SECTION 904 - NOTICE TO BIDDERS NO. 7319

SUBJECT: Pay Item Corrections and Additional Construction Requirements

PROJECT: STBG-7903-00(002) / 109695301 – Desoto County
STBG-0914-00(041) / 109696301 – Marshall County
NHPP-0006-01(107) / 109698301 – Desoto County
NHPP-0006-01(108) / 109699301 – Marshall County

ADDENDUM

WK. NO. PR-1	SHEET NO. 8002
-----------------	-------------------

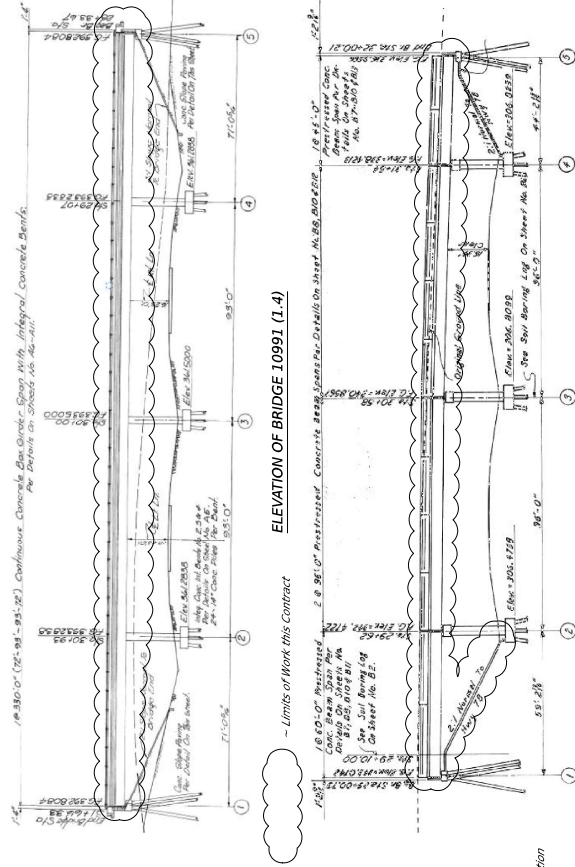
The Bidder's attention is called to Sheet No. 8003 (Wk. No. A1 of A7). Fine Milling will be used in place of Cold Milling. Any reference to Pay Item No. 406-A002, Cold Milling of Bituminous Pavement, All Depths, in the Contract Plans shall be understood to mean Pay Item No. 406-D001, Fine Milling of Bituminous Pavement, All Depths. The bid sheets are correct.

BRIDGE DIVISION			
REVISIONS			
DATE	SHEET NO.	DESCRIPTION	BY
10/2/2025	8003	Removed Fine Milling Alternate Bid Pay Item & Notes Associated with Fine Milling Pay Item	JAF
10/6/2025	8004	Revised Temporary Shoring Notes	CBG
